**ADDENDUM NO. 1**

Plans and Specifications for: **Walnut Street Reconstruction – 2<sup>nd</sup> Street to 4<sup>th</sup> Street**

## DOCUMENT 009113 – ADDENDA 1

01 FIRE PIT AREA

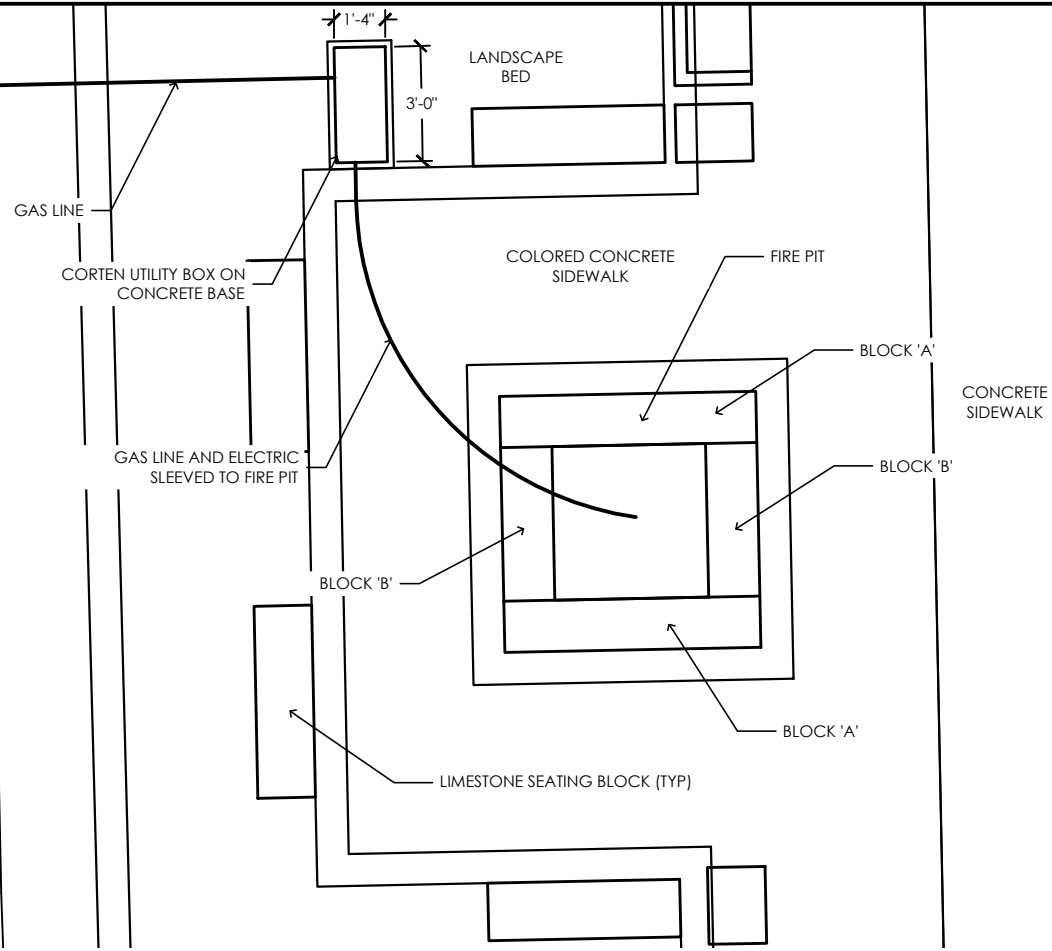
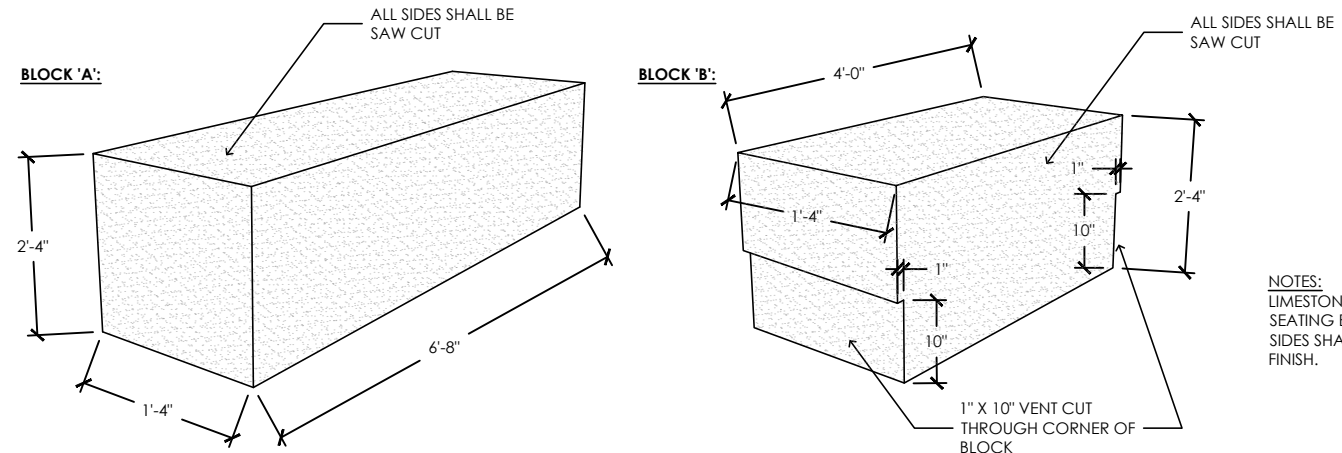
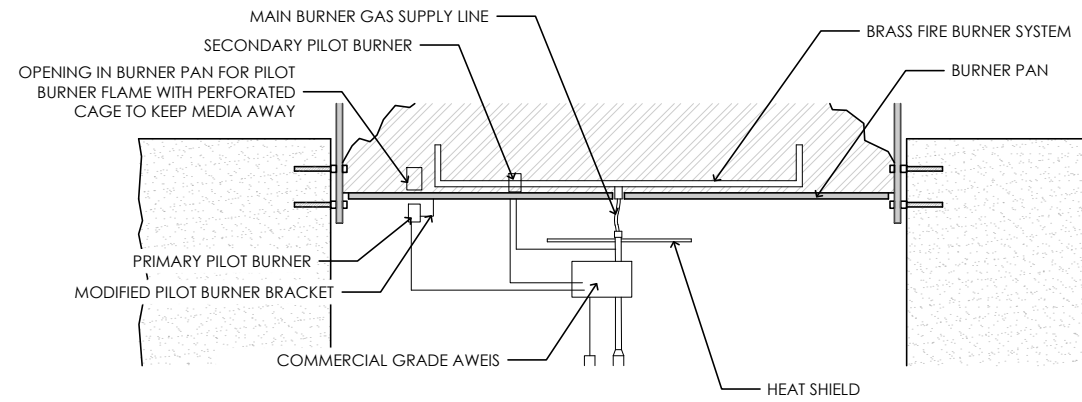
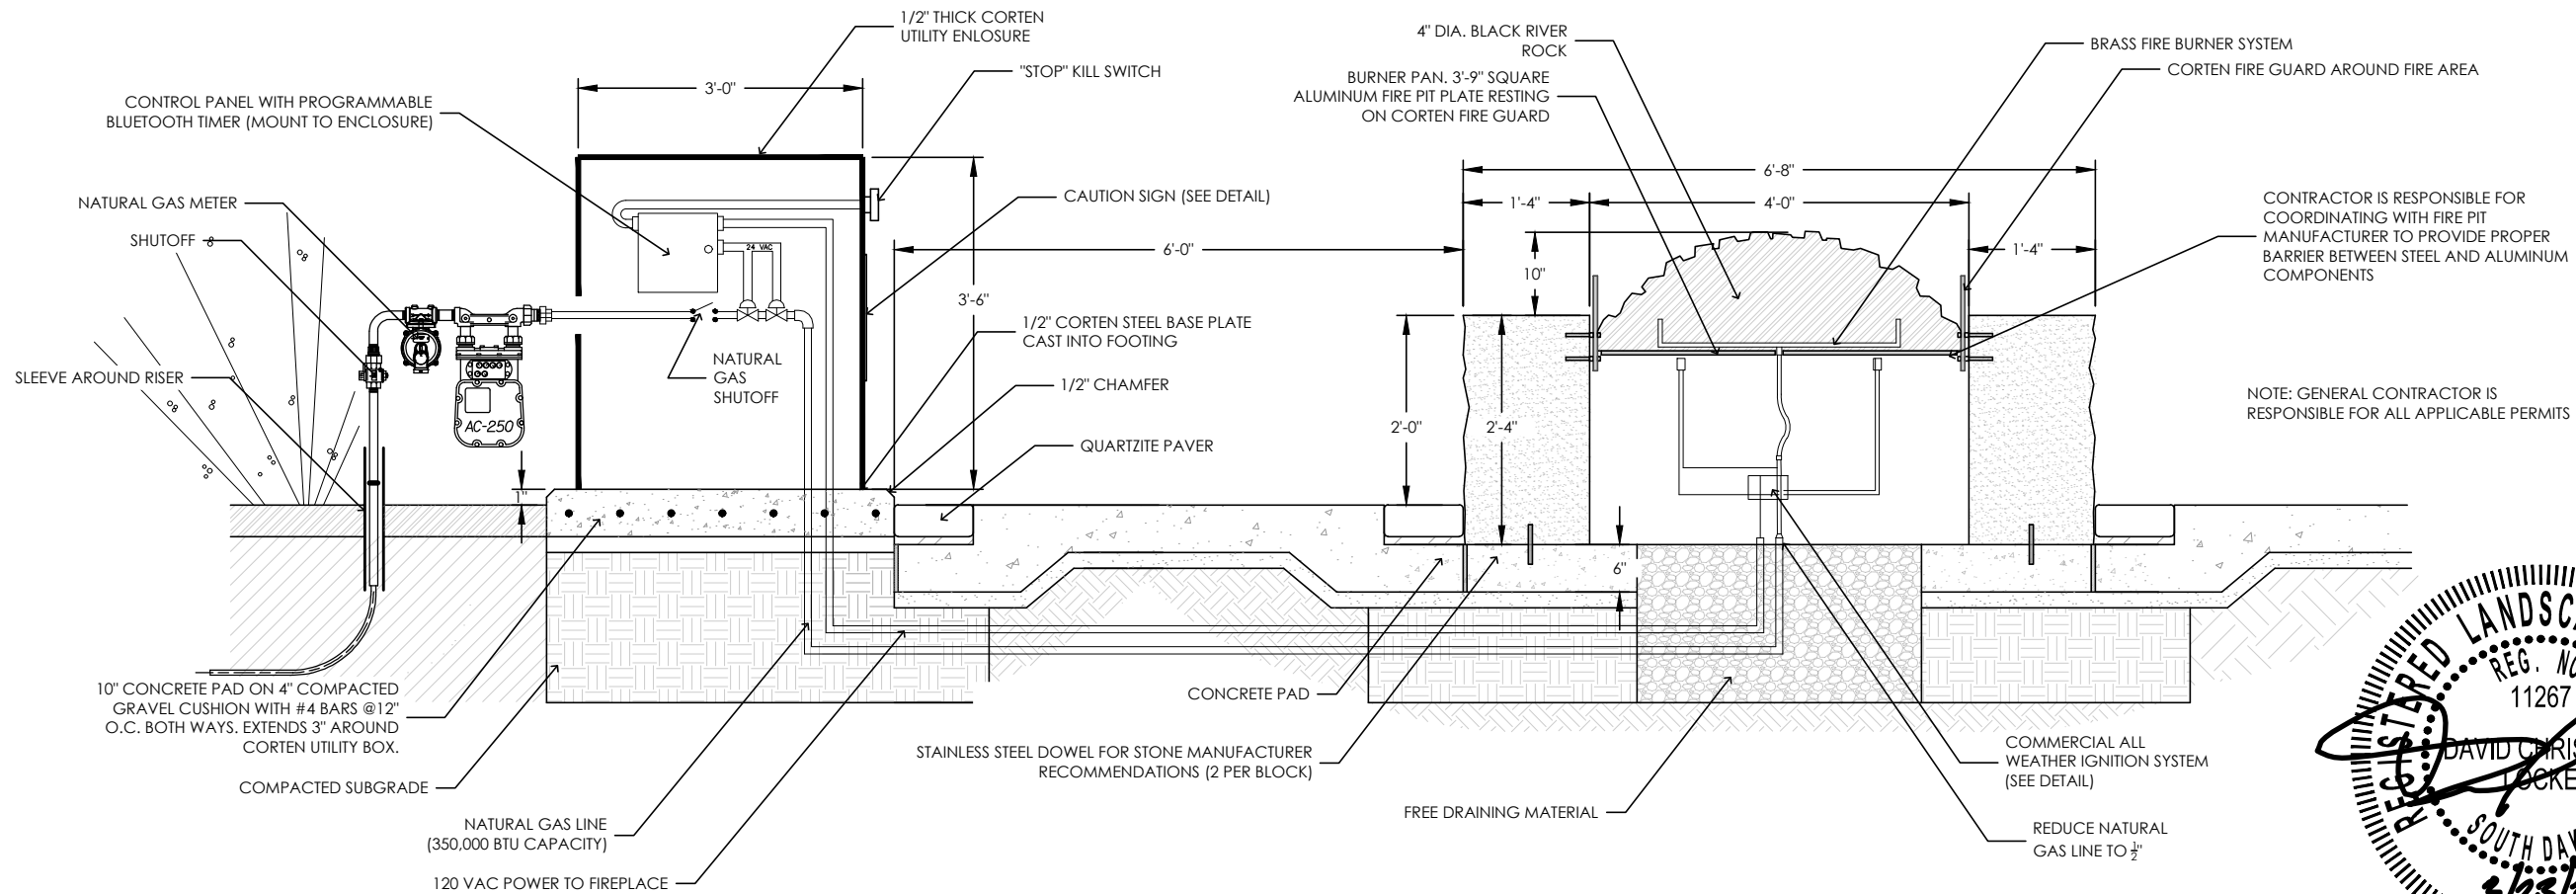
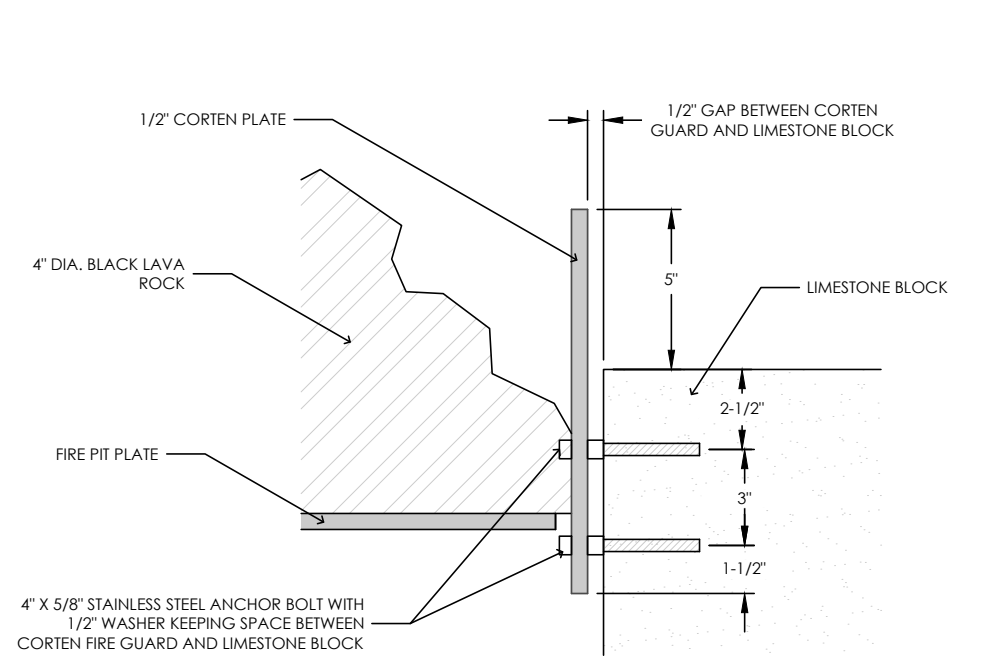
- a. Updated all elements of fire feature detail.
  7. Landscape Details Sheet L4.07, dated March 23, 2018, reissued.
    - a. Added caution sign location to enclosure.

**L4.09**

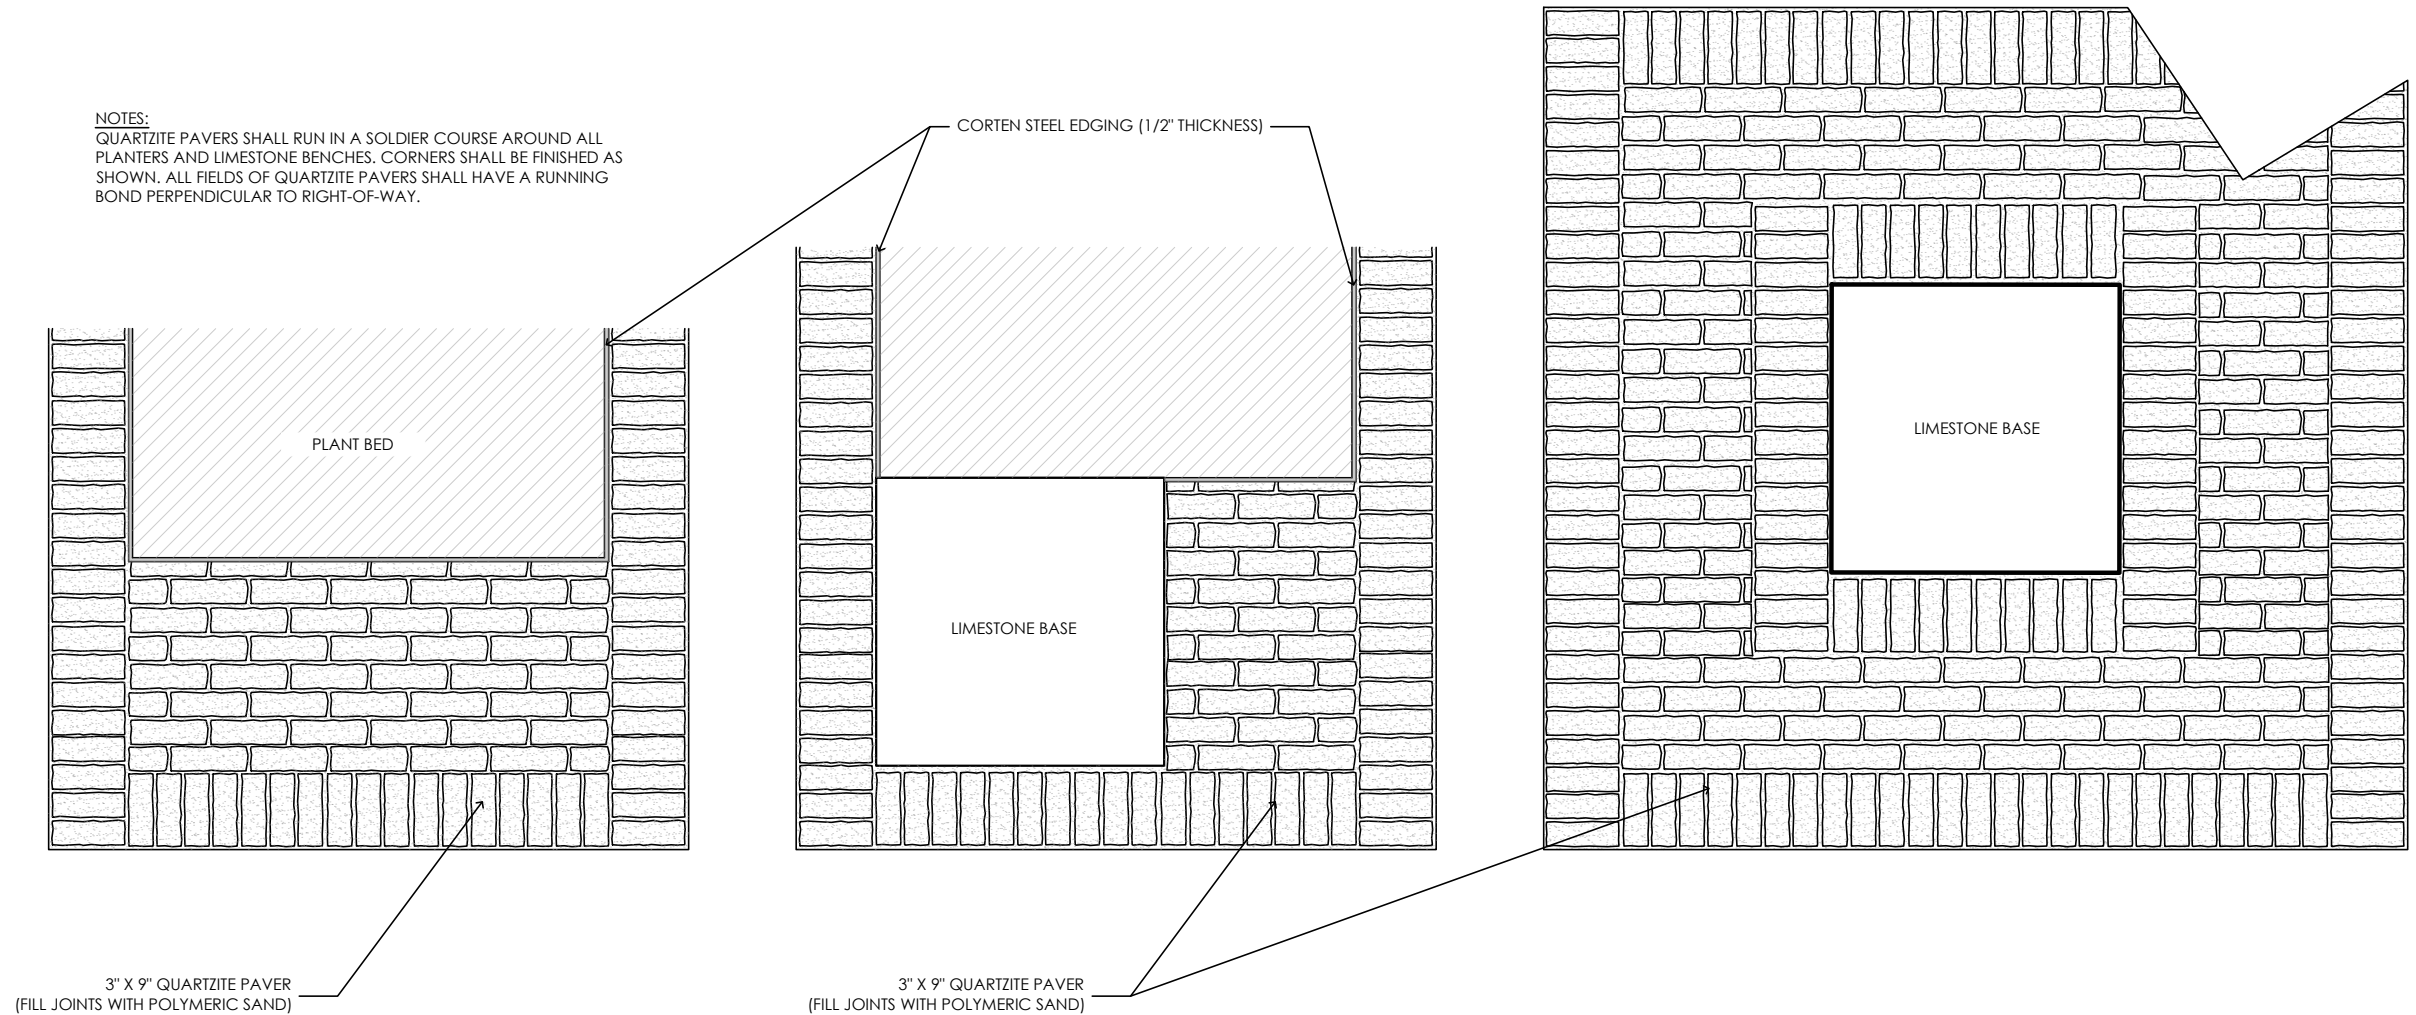
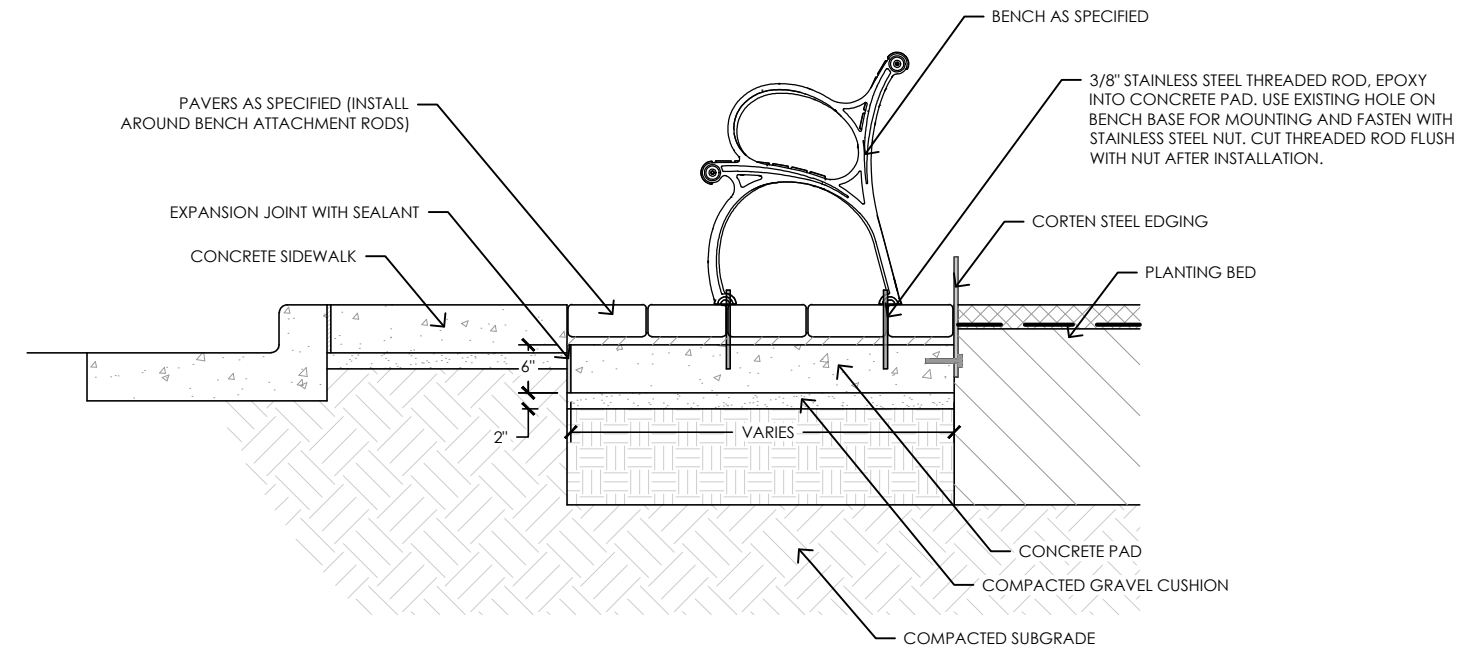
- a. Added additional quartzite paver pattern details and bench attachment detail.
